Access Compliance Report

Public Rights-of-Way

Intersection ID: 27742	Main Street: BREM_LN	Cross Street: OLD_WAYSIDE_RD	Location: SW
ADA ID: 41354C1577CF	Ramp Type: BlendTrans2	Initial Pass/Fail: Fail	Overall Compliance: No
		Severity Score: 25

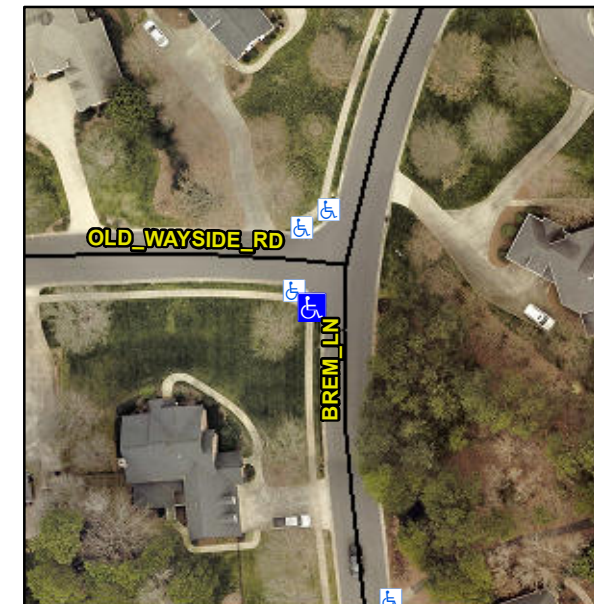
Not Found, R304.5.3

Compliance	Description	Data	Compliance	Description	Data
N/A	Ramp Length (in)	94.0	Yes	BlendTrans Slope (%)	4.1
Yes	Ramp Width (in)	48.0	No	BlendTrans XSlope (%)	8.0
N/A	Flare Type LT	N/A	N/A	Flare Type RT	N/A
N/A	Flare Slope LT (%)	N/A	N/A	Flare Slope RT (%)	N/A
N/A	Flare Traversable LT?	N/A	N/A	Flare Traversable RT?	N/A
N/A	Landing Length (in)	N/A	N/A	DWS Provided?	N/A
N/A	Landing Width (in)	N/A	N/A	DWS Contrast?	N/A
N/A	Landing Slope (%)	N/A	N/A	DWS Length (in)	N/A
N/A	Landing X Slope (%)	N/A	N/A	DWS Full Width?	N/A
N/A	Landing Curb? (Y/N)	N/A	N/A	DWS Offset (in)	N/A
N/A	Shared Landing?	N/A			
N/A	Gutter Ponding?	N/A	N/A	Gutter Slope (%)	N/A
N/A	Gutter Lip Ht (in)	N/A	N/A	Gutter X Slope (%)	N/A
N/A	Painted X Walk1?	No	N/A	Painted X Walk2?	N/A
	X Walk 1 Direction	To E		X Walk 2 Direction	N/A
	X Walk 1 Width (in)	N/A		X Walk 2 Width (in)	N/A
	X Walk 1 Slope (%)	3.6		X Walk 2 Slope (%)	N/A
	X Walk 1 X Slope (%)	4.3		X Walk 2 X Slope (%)	N/A

N/A	Ramp inside XWalk1?	N/A	N/A	Ramp inside XWalk2?	N/A
	Road Slope (%)	4.3		Clear Space?	N/A
	Road X Slope (%)	3.6	N/A	Clear Space to XWalk (in)	N/A
N/A	Any Obstructions?	N/A	N/A	Storm Grate/Utility Hazard?	N/A
	Obstruction Type			Storm Grate/Utility Type	
		N/A			N/A
			Yes	Surface Condition? (G/P)	Good
			No	Curb Slope (%)	9.5

Remove & Replace Curb Ramp With Two New Directional Ramps or Equivalent.
